SERVICETEKNOTES

TABLE OF CONTENTS

7L5: Cable Assembly Part Numbers (continued)

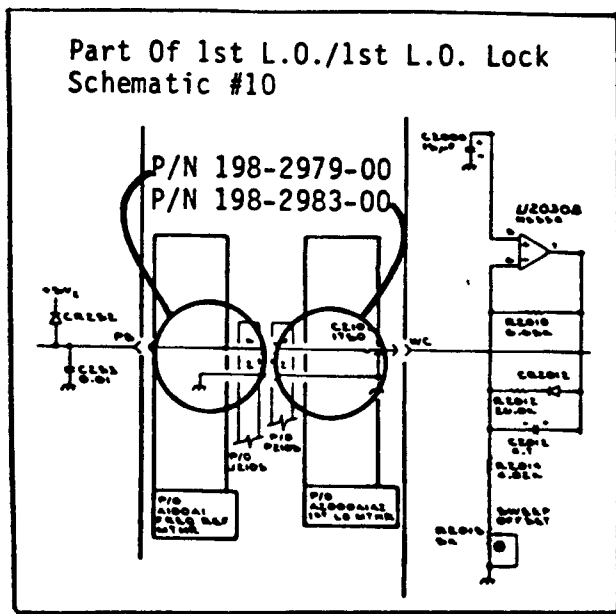
The following figures provide part numbers and other pertinent information for three 7L5 Cable assemblies. Part numbers for these items do not appear in the service manual electrical or mechanical parts lists. Please record this information in your service manuals for future reference.

The P/N 175-5415-00 is a 34 wire ribbon cable which connects the A2000A2 Vertical Control assembly and A1000A1 I.F. Mother assembly at P1010. The cable is soldered to the back side of the Vertical Control assembly.

The P/N 198-2979-00 and P/N 179-2983-00 form a shielded Coax Cable assembly

which provides a 1st L.O. Phase Lock Error Voltage signal path from the A100A5 1st L.O. Lock board to the A2000A1A1 1st L.O. board. These grey cable assemblies are located near the rear of the instrument, and interconnect via a 3 pin harmonica connector (P2105/J2105).

Partial A6 Reference Board

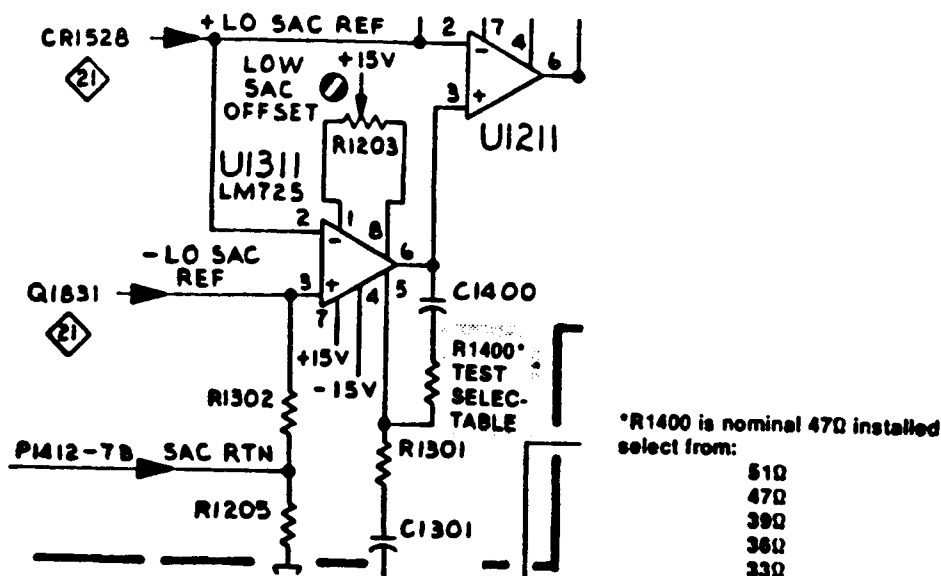
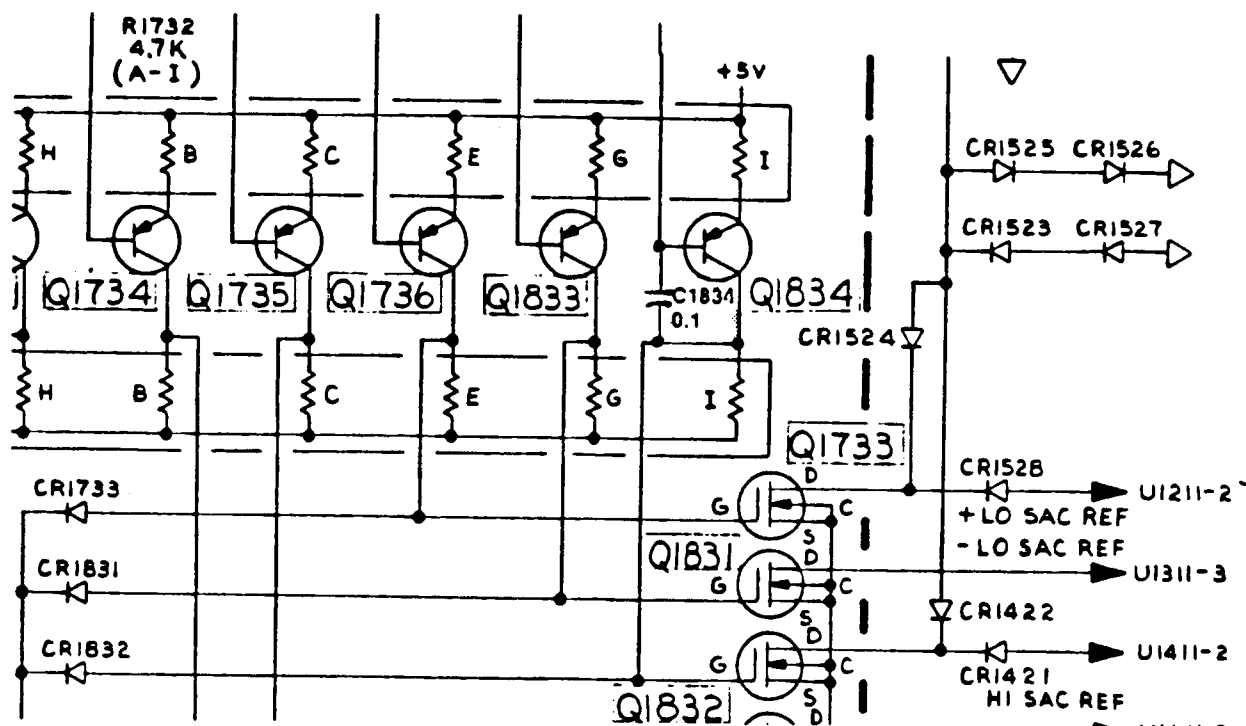
Change Reference: M62994

Component No.	Part No.	Description
A6	670-6088-10	Circuit Bd Assy: Reference
A6Q1832	151-1103-00	Transistor, FET, N-Channel
A6U1241	156-0719-00	Microcircuit, D/A Converter
A6R1400		Resistor, TEST SELECTABLE Nominal installed value to be 47 Ω p/n 315-0470-00.

Fig. A. Waveforms indicating A6R1400 value is: (A) properly selected; (B) too large; (C) too small.

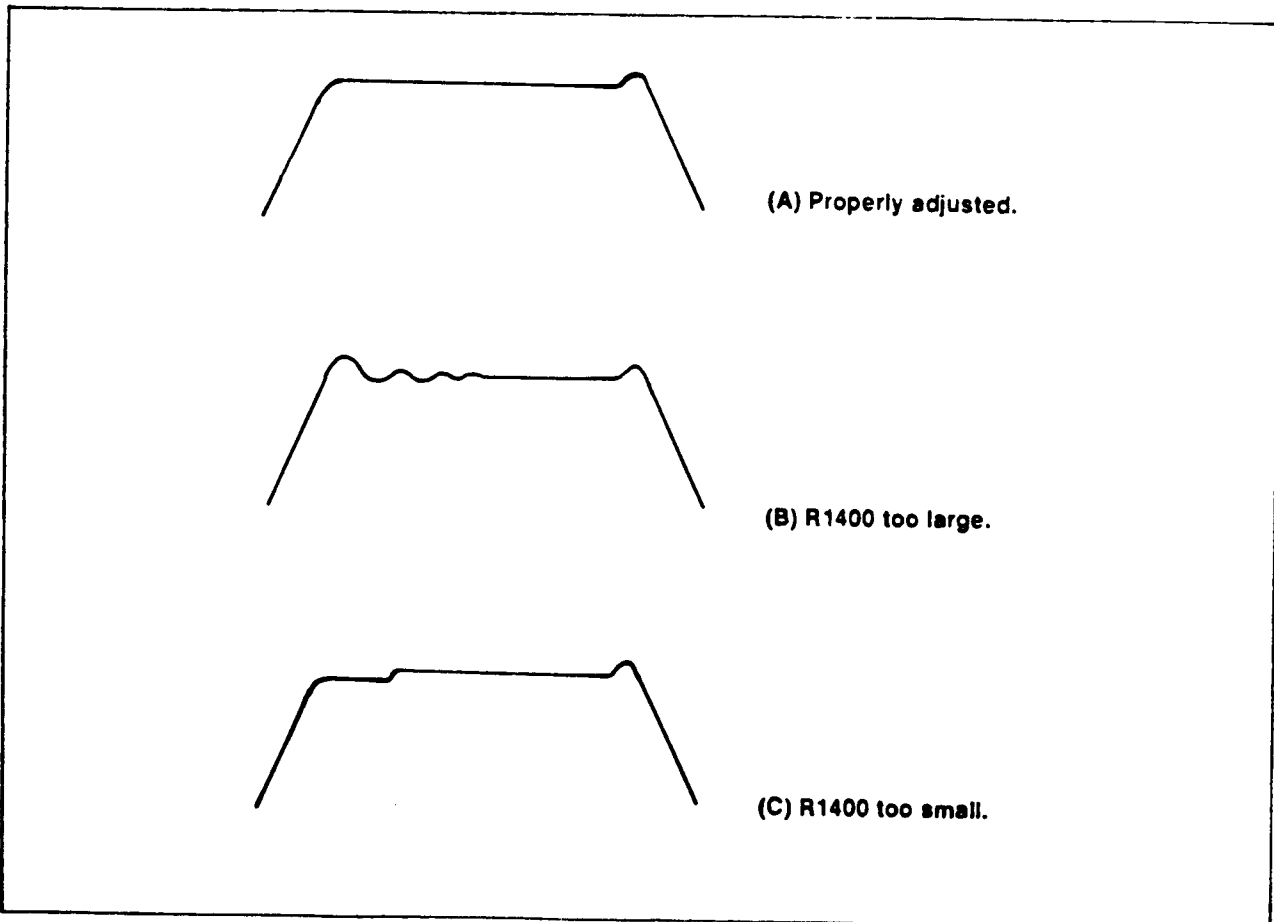
h. If the leading edge corner and top of the waveform does not look like Fig. A, a new value for A6R1400 must be selected. Select one of the following to replace the existing A6R1400 value depending on the waveform appearance.

i. Repeat 13f, then 13h until the waveform appearance is similar to that in Fig. A.

NEW PART LOCATIONS ARE SHOWN BELOW.

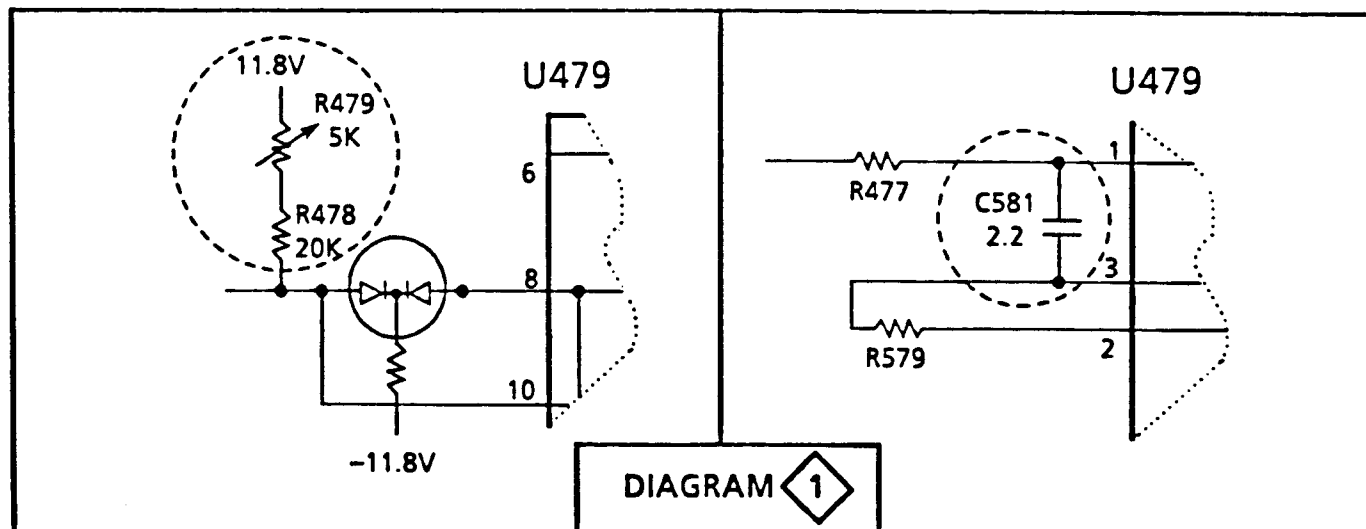
ADD:

A3C581	281-0756-00	CAP,FXD,CER DI: 2.2PF, ± 0.5 PF, 200V
A3R479	311-2234-00	RES,VAR,NONWW: TRMR, 5K OHM, 20%, 0.5W LINEAR

**CHANGE, on pages 6-20 and 6-21, part f of step 22 TO READ:****Fig. 6-25 Kinescope neck components.**

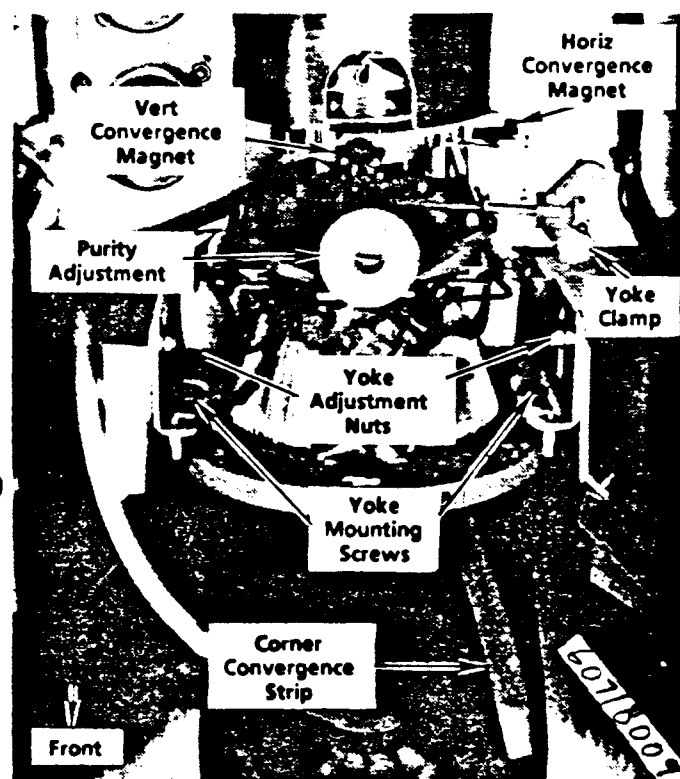
Date: 10-10-86Change Reference: M61658Product: See ListManual Part No: See List**DESCRIPTION**650
653/656HREFF SN B056190
EFF SN B050670070-2646-01/02
070-2647-00**MECHANICAL PARTS LIST AND TEXT CHANGES****CHANGE TO READ:**

1-70	407-3577-00	BRKT, ANGLE
1-70	407-3578-00	BRKT, YOKE MTG.
1-87	211-0418-00	METRIC SCREW
1-87	210-0805-00	WASHER, FLAT
—	220-0407-00	NUT, HEX (YOKE ADJ)
—	210-0457-00	NUT, PL, ASSEM
—	211-0507-00	SCREW, MACHINE

- f. **ADJUST** – Turn the Purity adjustment (see Fig. 6-25) to obtain a uniformly red display. If further improvement is necessary, loosen the yoke clamp, adjustment nuts and mounting screws. Slide forward or back to obtain the best red screen display. Display a convergence crosshatch pattern. Rotate the yoke so the center vertical line is vertical. Retighten the yoke clamp, adjustment nuts and mounting screws. Display a 100 IRE flat field signal. If necessary, readjust the Purity adjustment. If there is still some impurity, use a hand-held degaussing coil to completely degauss the monitor.
